**AGENDA**  
**HISTORIC PRESERVATION BOARD**  
City Commission Chambers  
April 22, 2021 8:30 A.M.

<b>Project #</b>	<b>HPB21-030</b>
<b>Project Type</b>	<b>Siding and Windows Replacement</b>
<b>Property Address; Historic Name</b>	<b>302 W. Park Street; The H. D. Harvey House</b>
<b>Historic District; FMSF#</b>	<b>Dixieland Historic District; DL#86</b>
<b>Owner/Applicant</b>	<b>M &amp; P Restoration, LLC</b>
<b>Future Land Use; Zoning; Context District</b>	<b>Residential Medium; RA-4; Urban Neighborhood</b>
<b>Existing Use</b>	<b>Residential</b>
<b>Adjacent Properties</b>	<b>Residential</b>
<b>Previous Approvals</b>	<b>Replace windows and front door, HPB20-039 (3/23/2020).</b>

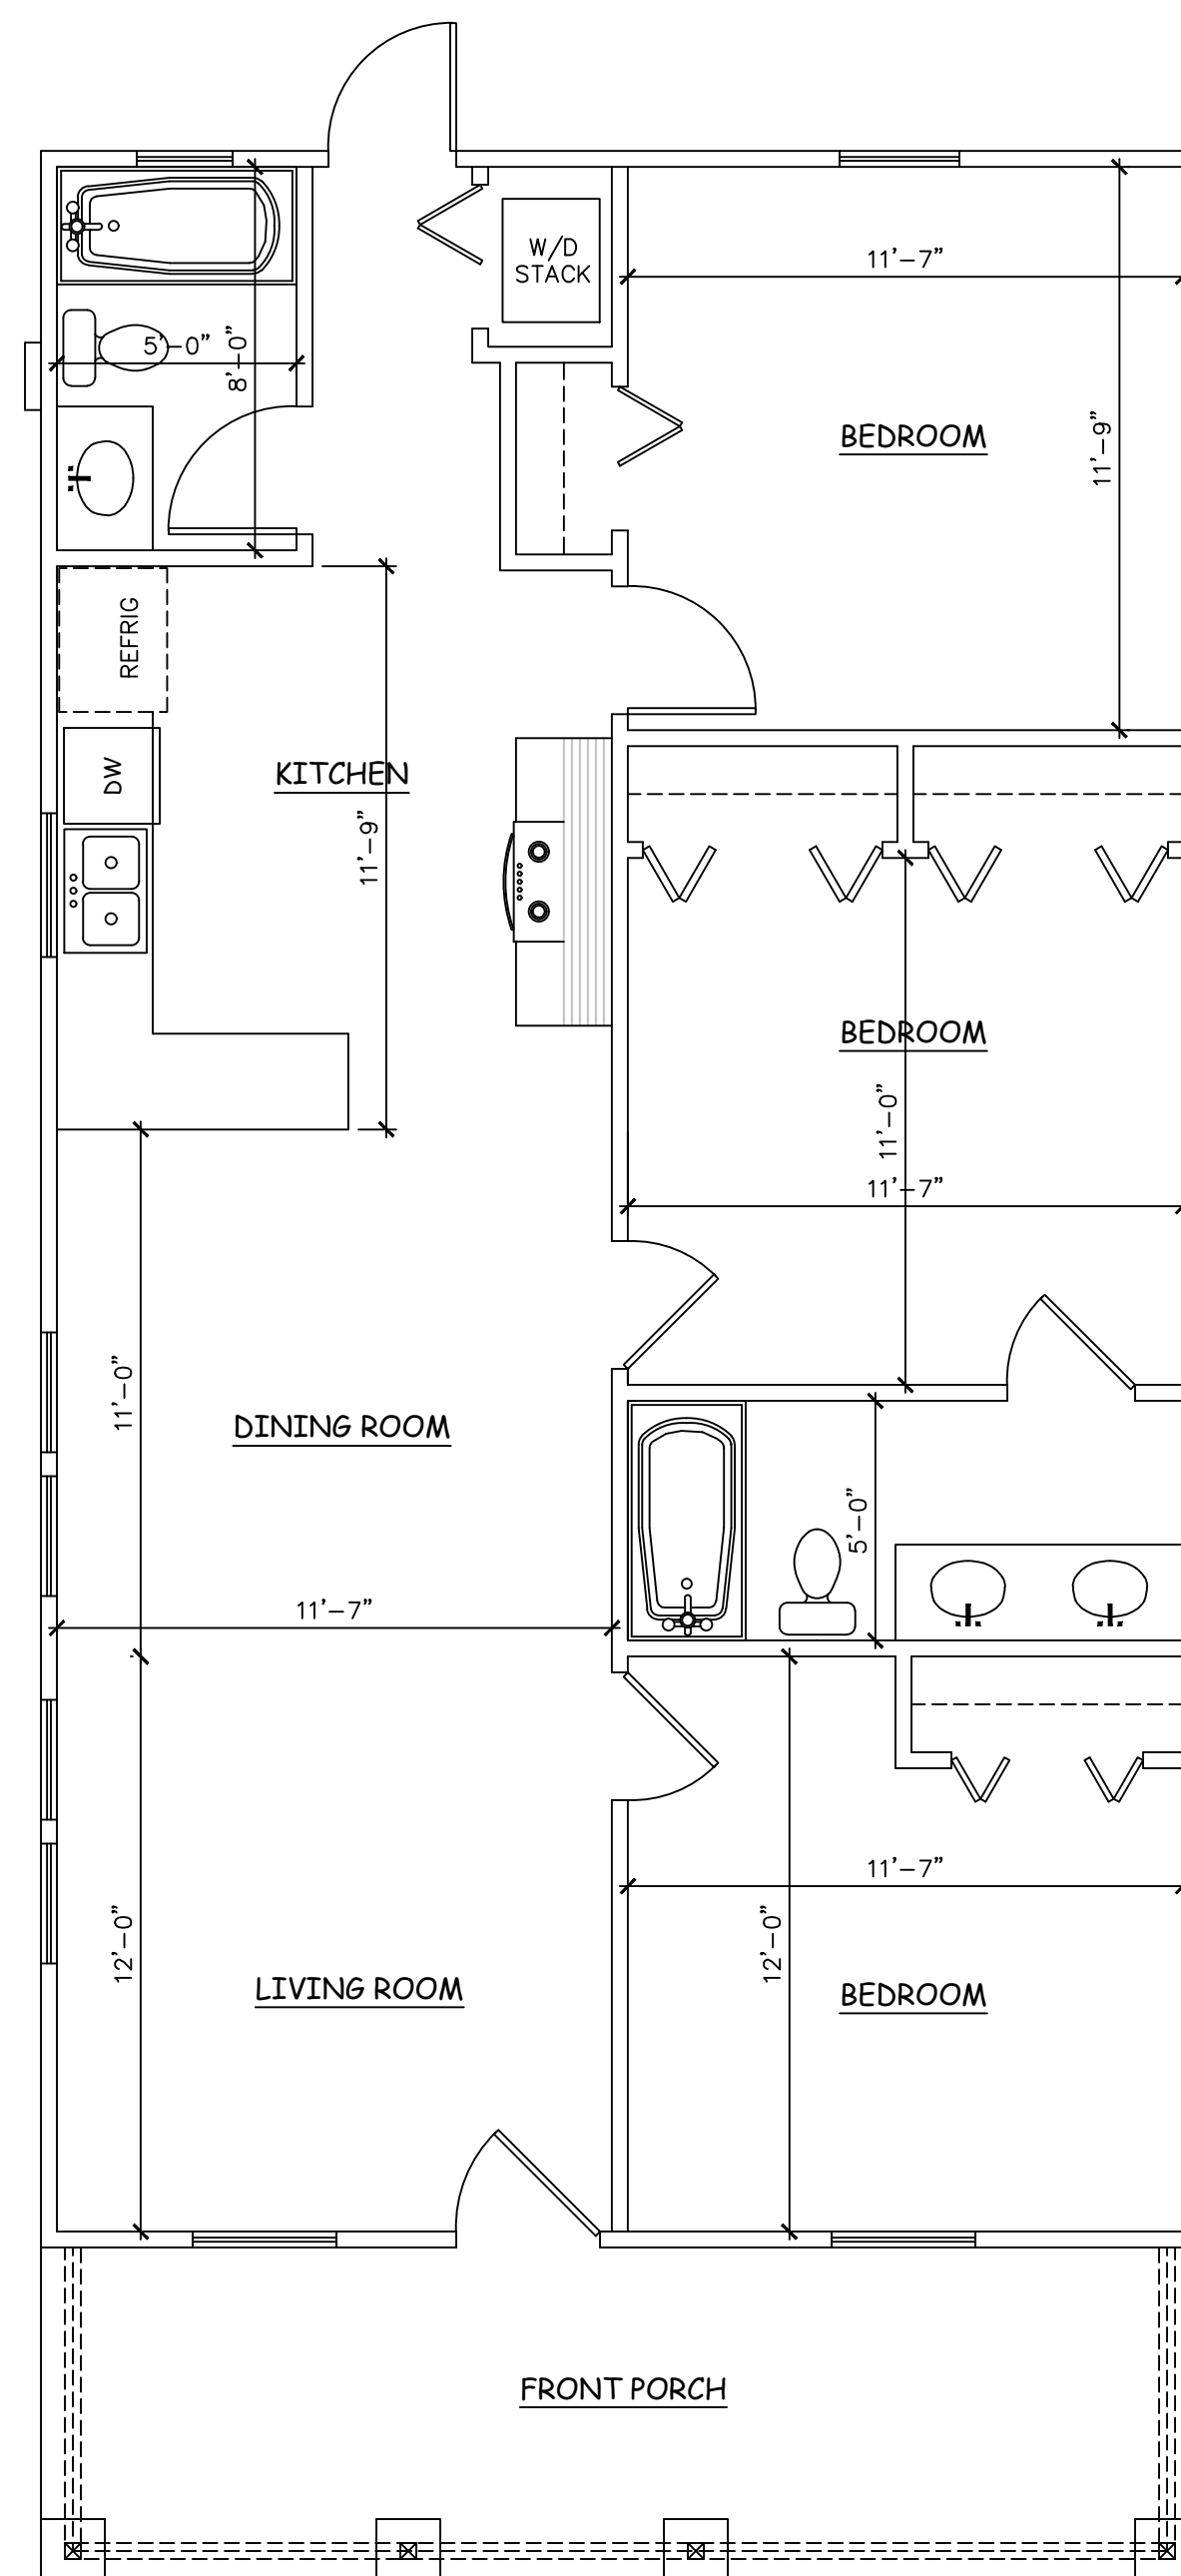
The Applicant requests approval to replace all existing windows in the subject house with vinyl windows that do not have an appropriate recess or match the opening size of the original windows on the east side elevation. In addition, the Applicant requests approval to replace all existing exterior drop-lap siding on the subject house with Hardie board lap siding with a 5.25-inch exposure. This request was continued to April 22, 2021.

windows are not recessed into the wall plane, as the original windows were, and instead project from the exterior wall surface. The replacement windows also do not feature an upper sash with exterior-mounted muntins matching the three lite appearance of the historic windows. Finally, all window trim and casing has been removed, which is beyond the scope of work approved by Certificate of Review HPB20-039.

Finally, the removal of the wood tapered columns and replacement with the columns as shown on the proposed elevation drawing is not acceptable according to the Design Guidelines; tapered columns matching the profile and dimension of the original columns in either wood or cement-fiber material should be used.

1. Use replacement windows that have the following characteristics:
  - a. Box or block-framed replacement windows of the same dimensions of the original windows are suggested, which will provide a recess into the wall plane similar to the original windows that were removed;

- d. All window trim must replicate the original in dimension and include a drip edge, header, sill, and apron.
2. Retain and repair the existing siding with in-kind materials or replace with drop-lap siding matching the profile and dimension of the original siding.

3. Replace the front porch columns that were removed with tapered columns matching the profile and dimension of the original columns in either wood or cement-fiber material.
